**RAI Volume 4, Chapter 2.5.8, First Set, Number 1:** Provide the value for the maximum amount of water needed in any year to accomplish the purpose of the geologic repository operations area, for both construction and operations, specifically in reference to the discussion in SAR Section 5.8.4, and Repository Supplemental EIS Section 4.1.3.2.3 and Table 4.6.

ENCLOSURE 4

Response Tracking Number: 00208-00-00

Figure 1. GROA Boundaries

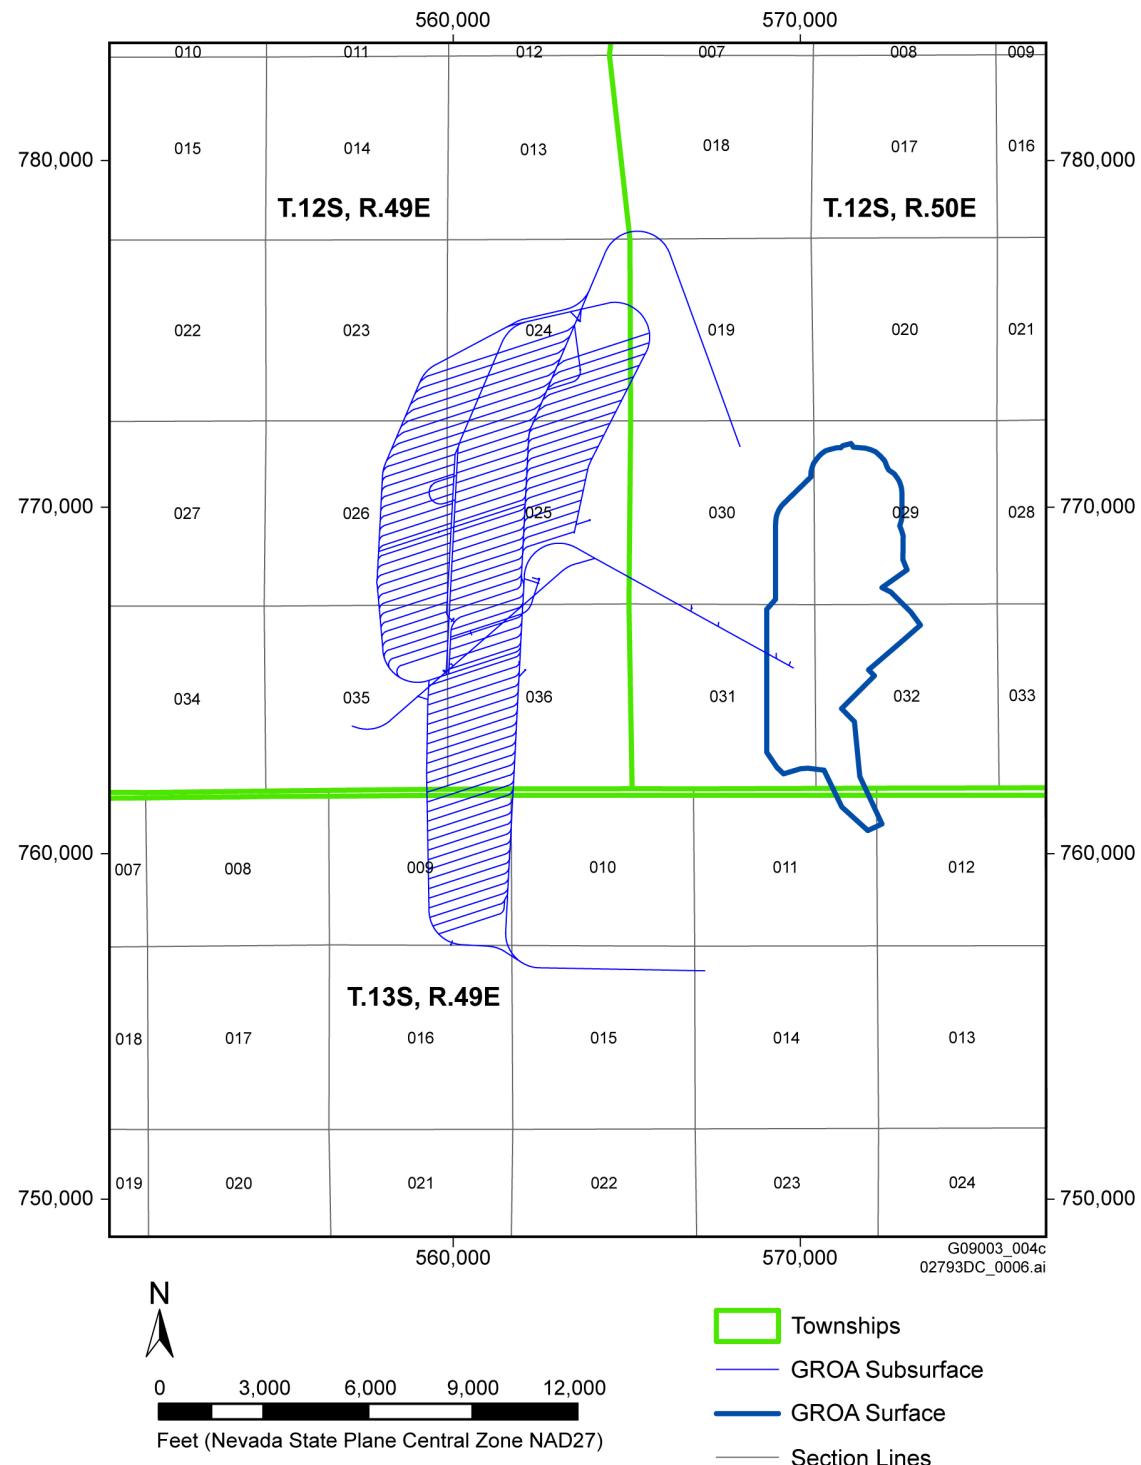
**RAI Volume 4, Chapter 2.5.8, First Set, Number 5:** Provide a specific description of the boundaries of the entire geologic repository operations area at a level of detail appropriate for records associated with land ownership.

10 CFR 63.2 defines the geologic repository operations area (GROA) as "a high-level waste facility that is part of a geologic repository, including both surface and subsurface areas, where waste handling activities are conducted." Consistent with this definition, SAR Section 1.1.1.1.4 defines the GROA in the same manner and describes the GROA to include: (1) the maximum extent of the surface portion of the GROA (based on phased development), where the boundary of this area encompasses both the protected area and the restricted area, including the area in the vicinity of the aging pads, and (2) the subsurface portion of the GROA repository layout, including ramps and shafts. Figure 1 shows the site layout for the footprint for the surface and subsurface portion of the GROA, projected onto U.S. Bureau of Land Management Surface Management Maps of Nevada in 1988 through 1990.

The legal description of the GROA boundaries (for both the surface and subsurface portions) are as follows (by township, range, and section) in Public Land Survey System nomenclature, and contains a portion of, or is wholly encompassed within, the following sections and/or quarter sections:

Figure 1. Land Withdrawal Boundary (Preclosure Controlled Area and Site Boundary)

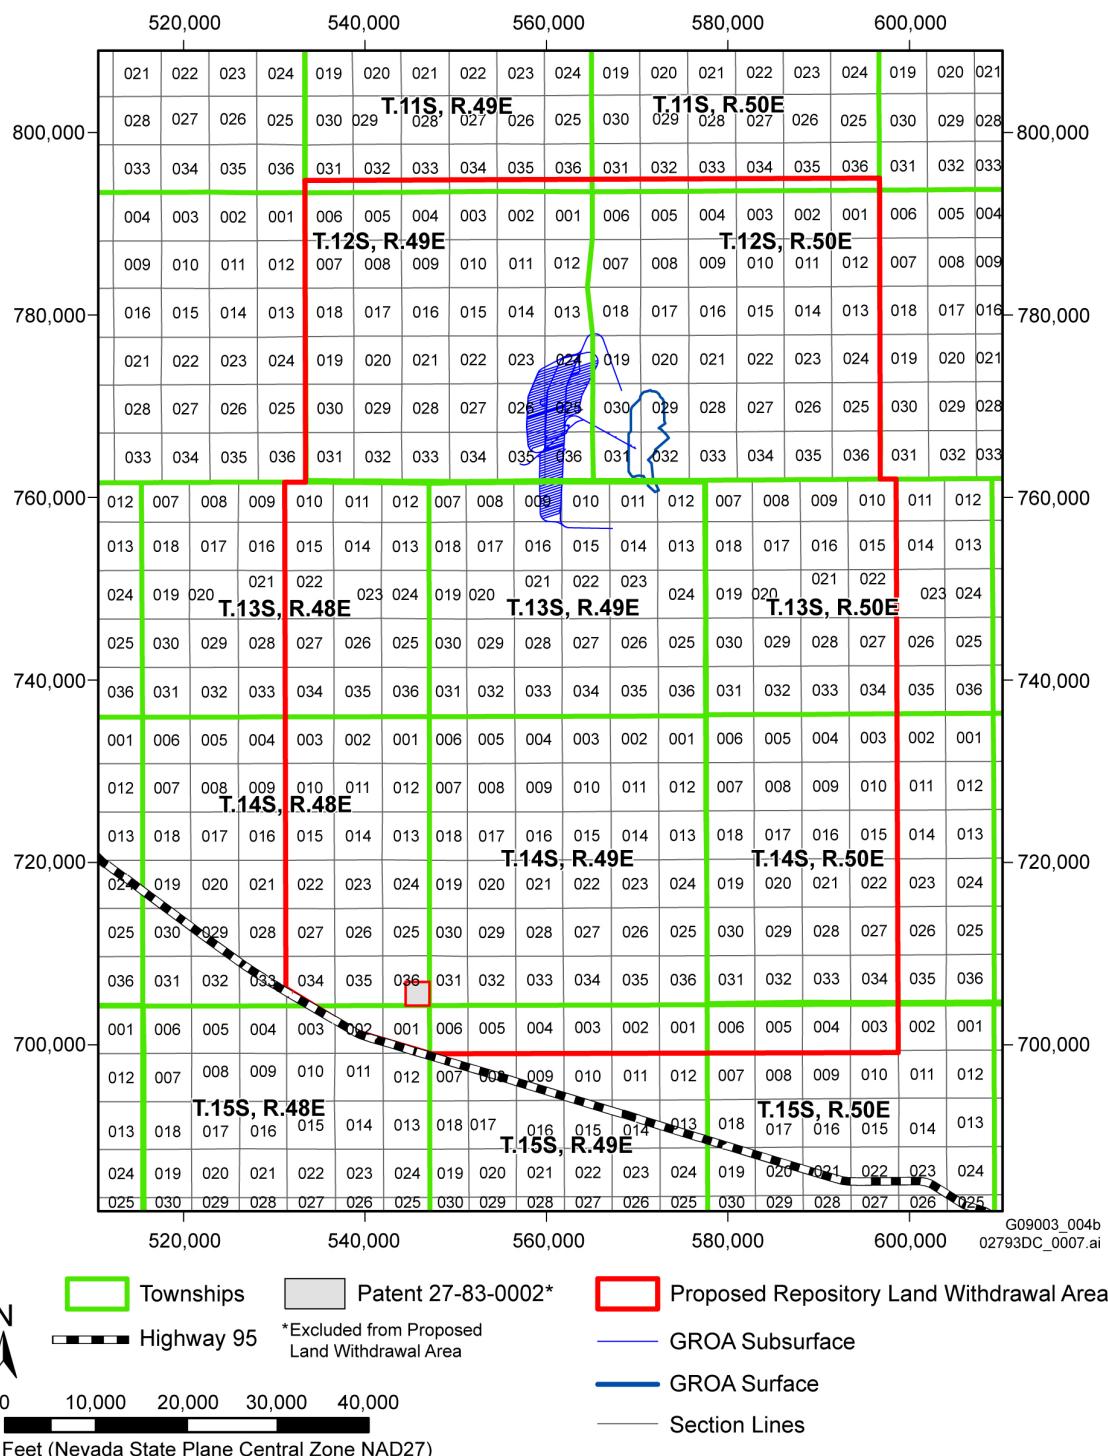
**RAI Volume 4, Chapter 2.5.8, First Set, Number 6:** Provide a specific description of the boundaries of the preclosure controlled area at a level of detail appropriate for use with other land records.

The site boundary, as described in SAR Section 5.8.3, will be considered as the boundary of the preclosure controlled area. The site boundary, as described in SAR Section 1.1.1.1, encloses the proposed land withdrawal area. The site boundary is the external boundary of the site and can be determined as the northern, eastern, southern, and western extent of the described lands. It is noted that the proposed land withdrawal area does not include the patented mining claim property (Patent 27-83-0002). The land withdrawal boundary (preclosure controlled area), projected onto U.S. Bureau of Land Management Surface Management Maps of Nevada in 1988 through 1990, is shown in Figure 1.

The legal description of the proposed land withdrawal area (and consequently the preclosure controlled area) is as follows (by township, range, and section) in Public Land Survey System nomenclature, and contains a portion of, or is wholly encompassed within, the following sections and/or quarter sections:

Figure 1. Postclosure Controlled Area

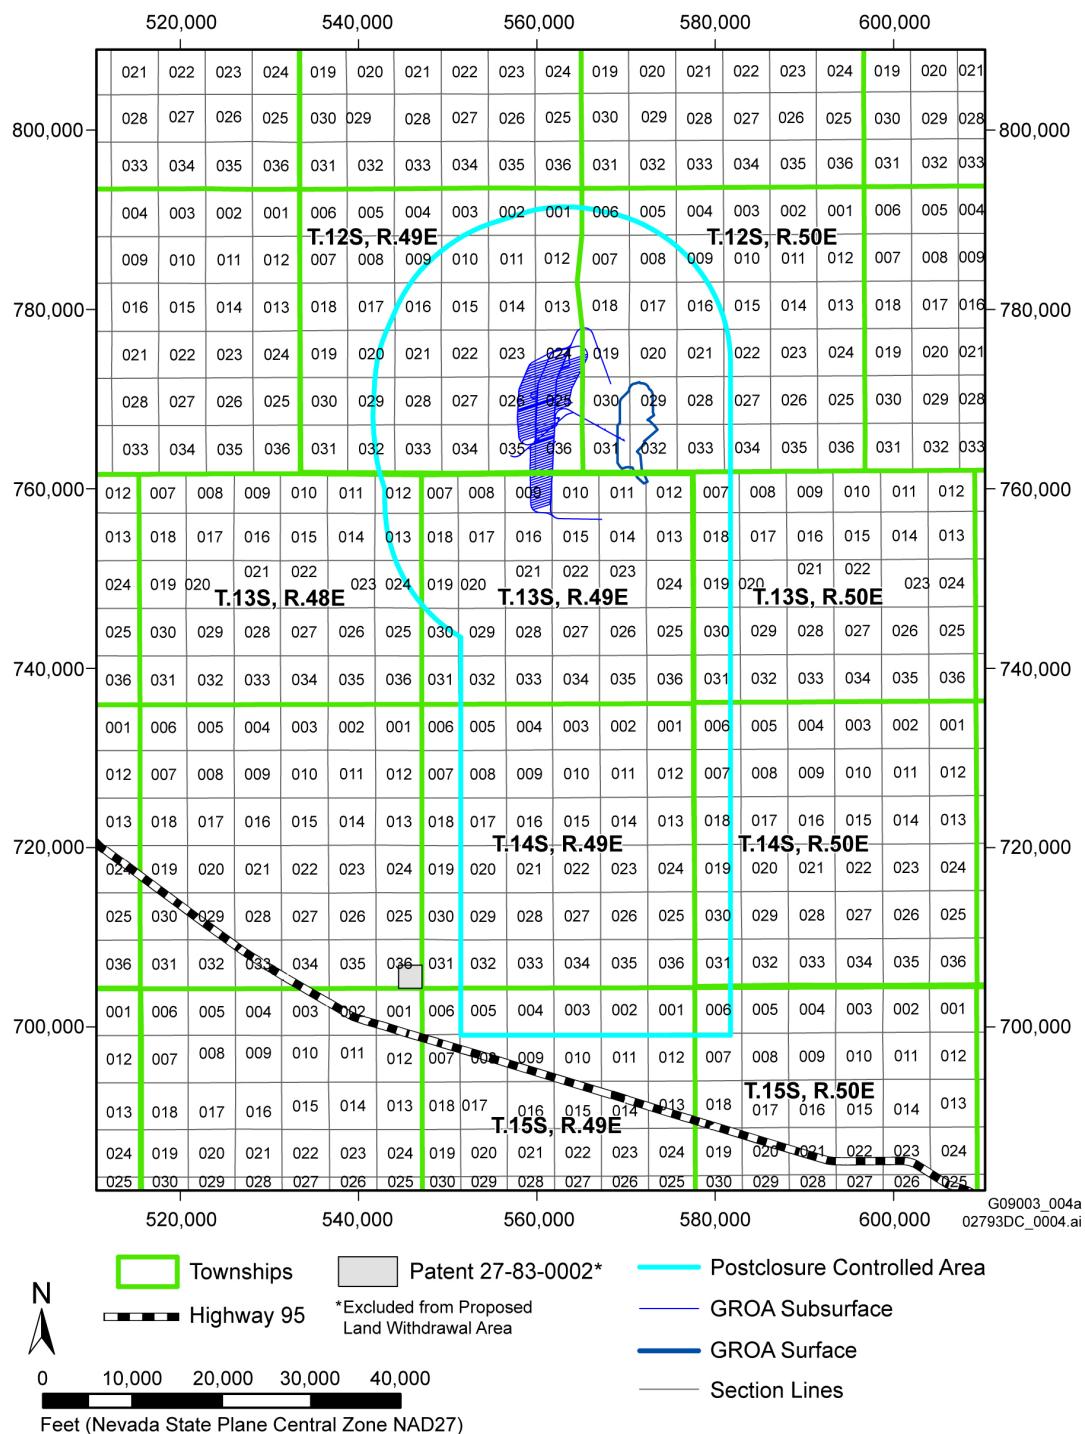
**RAI Volume 4, Chapter 2.5.8, First Set, Number 9:** Provide a specific description of the boundaries of the postclosure controlled area at a level of detail appropriate for use with other land records.

The postclosure controlled area for the repository, projected onto U.S. Bureau of Land Management Surface Management Maps of Nevada for 1988 through 1990, is shown in Figure 1.  $36^{\circ}40'13.6661''$  North latitude, as indicated in 10 CFR 63.302(1)(i), corresponds to the south section line of T. 15 S., R. 49 E, Sections 1, 2, 3, 4, and 5 and of T. 15 S, R. 50 E, Section 6.

The legal description of the postclosure controlled area is as follows (by township, range, and section) in Public Land Survey System nomenclature, and contains a portion of, or is wholly encompassed within, the following sections and/or quarter sections:
